Technical Bulletin 131

Tiger and Select inlet seal re-design

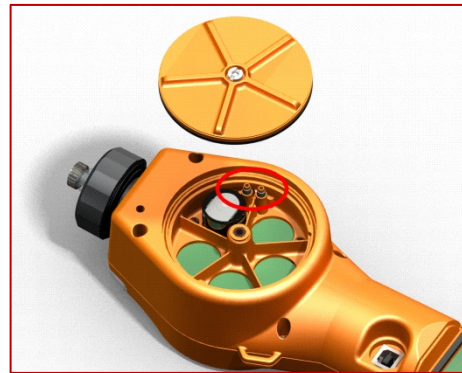
This has resulted in a slight change to the 'Inlet/Outlet seal' of the PhoCheck Tiger and Tiger Select products. (See diagram to the right)

The seals have been lengthened slightly to improve their ability to seal after being fitted for extended periods, and ensure improved seal integrity is maintained after the sensor cover is removed and refitted.

Please note that the seals are a direct replacement to the older style and are now fitted to all PhoCheck Tiger and Tiger Select instruments as standard. The seals can be retrofitted to any PhoCheck Tiger or Tiger Select, no modification to the instrument is necessary.

Inlet/Outlet seal: 861215
